## SERVICE BULLETIN

**TITLE: FLIGHT CONTROLS/STABILIZERS – AFT FUSELAGE, RUDDERVATOR, AND RELATED SYSTEMS INSPECTION FOR CONDITION**

Service Bulletin 27-3358, No Revision, is approved by the Manager, Wichita Aircraft Certification Office by letter dated February 11, 2000, as an Alternate Means of Compliance with AD 98-13-02, paragraph (f).

**Elevator Trim Tab Bracket Aft Rivet Edge Distance Inspection**  
**Figure 1**

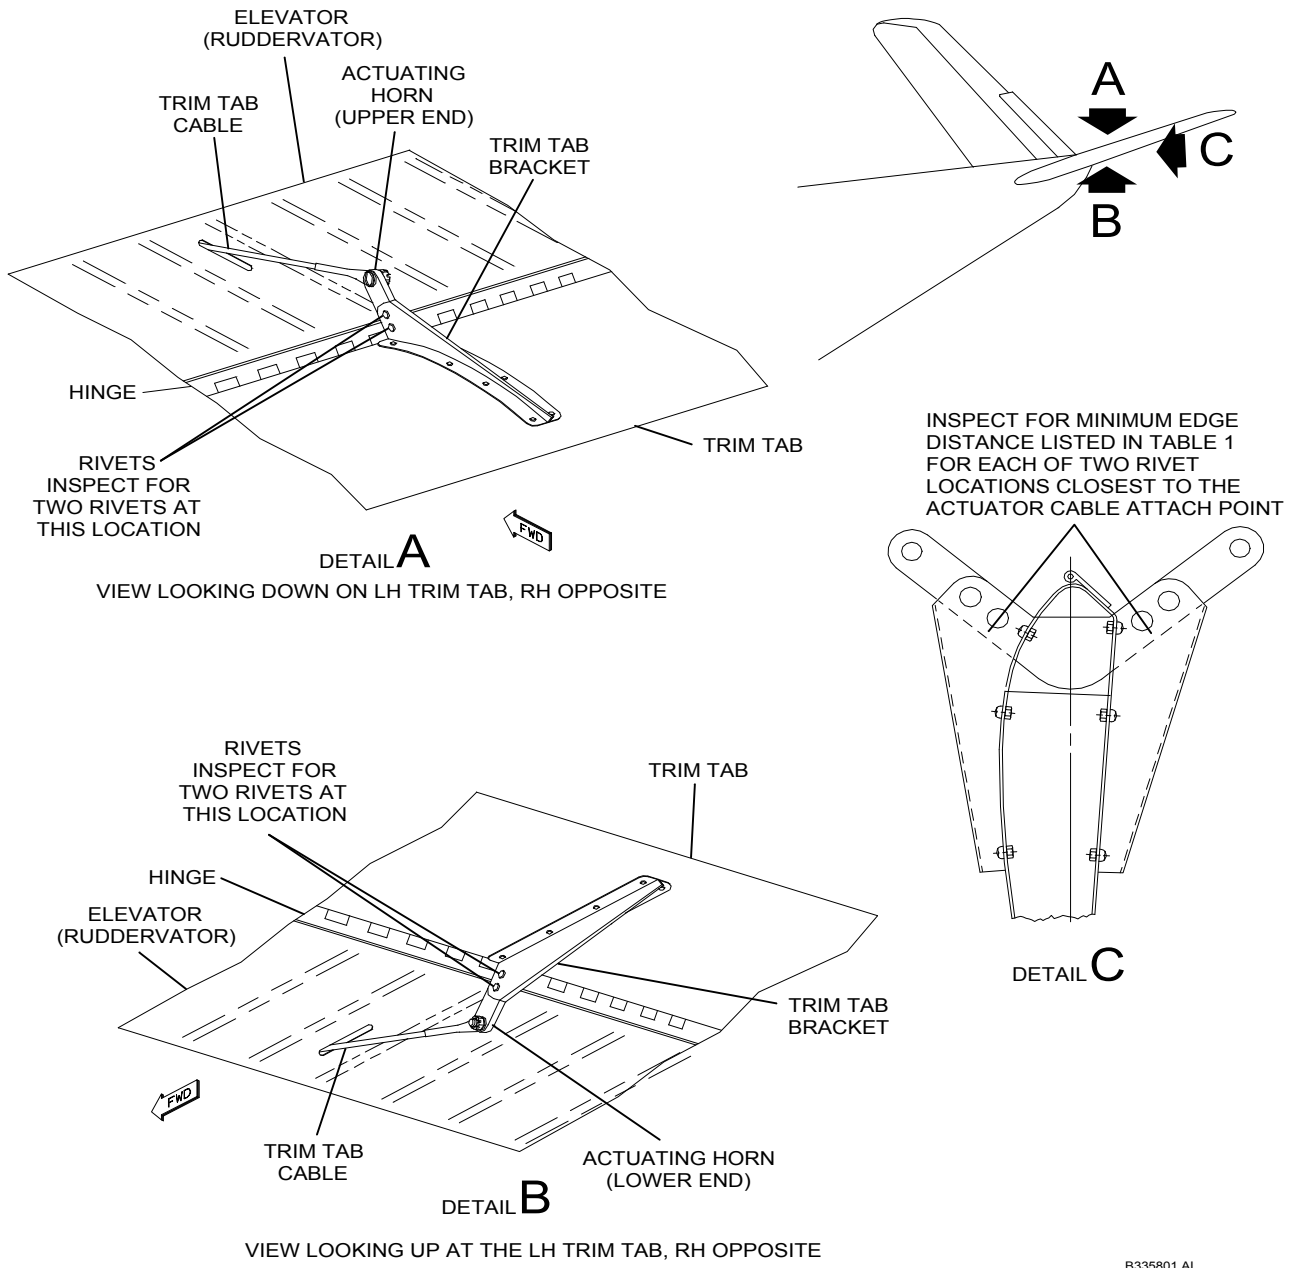
**If edge distance on the elevator tab horn MS20470AD3 rivets is short, the tab horn may separate from the control surface, resulting in loss of rudder control.**

- (iv) Inspect for presence of two rivets securing each trim tab bracket to the actuating horn to confirm compliance with Service Bulletin No. 2605. Refer to Figure 1 and inspect for minimum aft rivet edge distance at each of the two rivets closest to the actuator cable attach points on the actuating horn using the following table:

MODEL	PART	BJ-3 RIVETS MINIMUM EDGE DISTANCE	BJ-4 RIVETS MINIMUM EDGE DISTANCE
• 35	Magnesium Horn	0.11	0.13
• 35	Aluminum Horn	0.05	0.063
A35	Aluminum Horn	0.05	0.063
B35	Aluminum Horn	0.05	0.063
